**City of Ryde Submission
Road 1 Data Centre
1-5 Khartoum Road, Macquarie Park**

SSD-80814238

**Submission Date: 8 October 2025
COR2025/264/1**

Figure 1 – Contributory frontages map. The subject site is highlighted in green. The plan shows the requirement for a contributory frontage to Road No.1

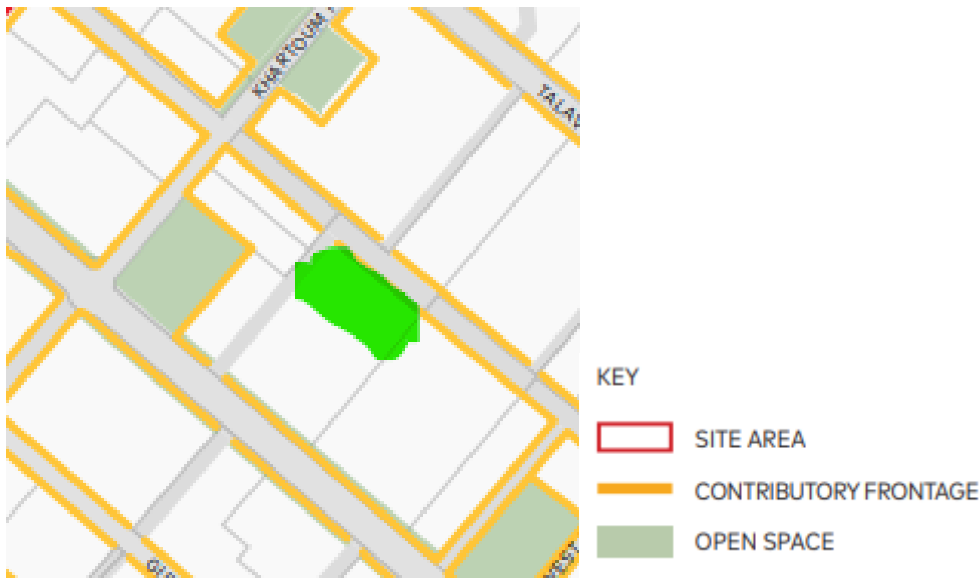
The proposed building has a limited extent of activation and visual interest to Road No.1 at the ground floor and first floor levels. It is considered that larger windows along this elevation would assist in street level activation, improving the passive surveillance of streets and enhance the overall commercial character of the precinct.

The amalgamation of the loading dock and carpark entry is suggested (if feasible) as it would assist in the activation of this frontage.

Figure 2 – Section depicting interface between road development site

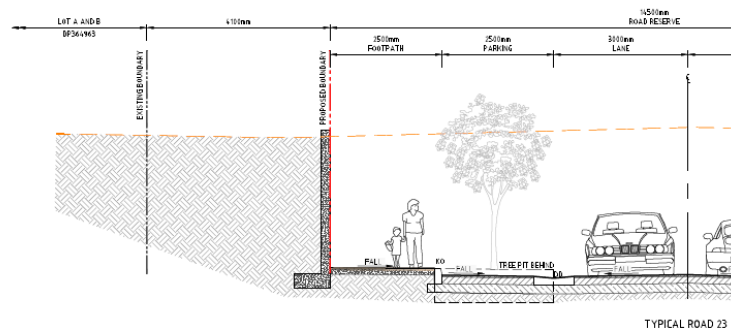
- d) The applicant is requested to provide kerb return sections to demonstrate adequate connection between Road No.1 and Road 22.
- e) Section A on DWG No. C09.01 of the Public Domain Civil Engineering Package shows an extremely high retaining wall at the road reserve interface with Lots A and B. This is not an optimal interface between a road reserve and private lot. Notation on the plan shows a boundary line amendment – is it possible to utilise this 4.1m to provide a better interface in the interim before Lots A and B are developed.
